Sundry ID: 2706634

**HILCORP ENERGY COMPANY**  
**Duff Gas Com 1E**  
**NOTICE OF INTENT TO PERMANENTLY ABANDON**

# BLM FLUID MINERALS P&A Geologic Report

**CONDITIONS OF APPROVAL**

**Duff Gas Com 1E - PROPOSED P&A SCHEMATIC**

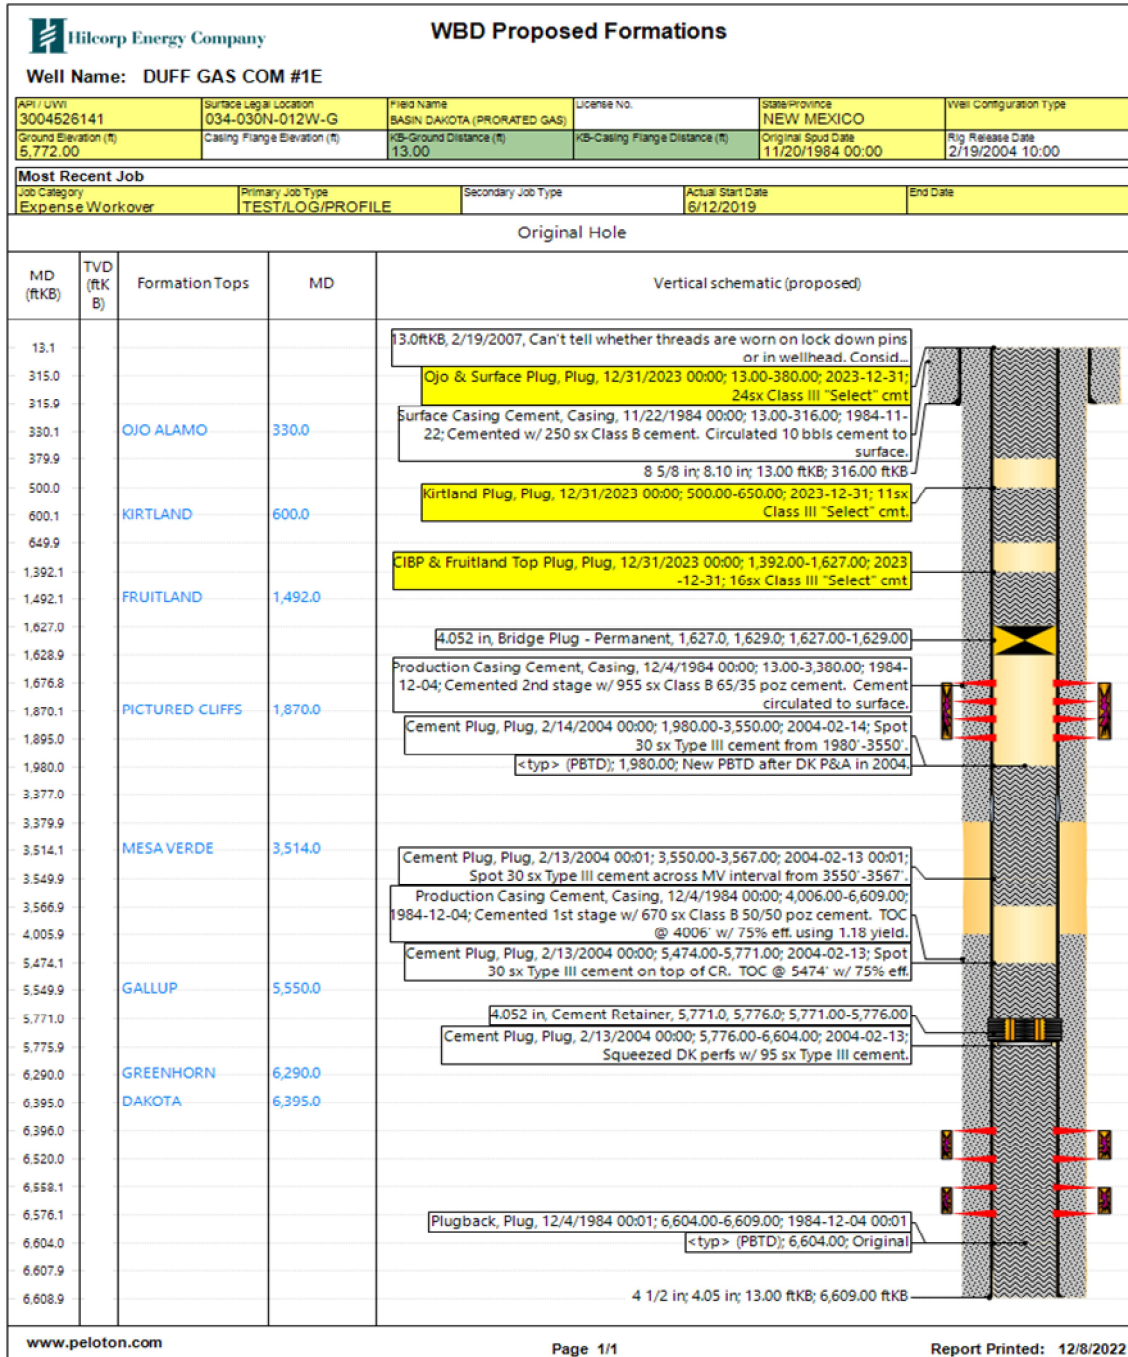
- BLM picks for the Ojo Alamo and Fruitland formation tops vary from Operator.

- Bring the bottom of Plug #1 down to 480', or combine with Plug #2 (Kirtland) to cover BLM pick for the Ojo Alamo formation top.

1. Plugging operations authorized are subject to the attached "General Requirements for Permanent Abandonment of Wells on Federal and Indian Lease."
2. The following modifications to your plugging program are to be made:
  - a. Bring the bottom of Plug #1 down to 480', or combine with Plug #2 (Kirtland) to cover BLM pick for the Ojo Alamo formation top.
3. Farmington Office is to be notified at least 24 hours before the plugging operations commence at (505) 564-7750.
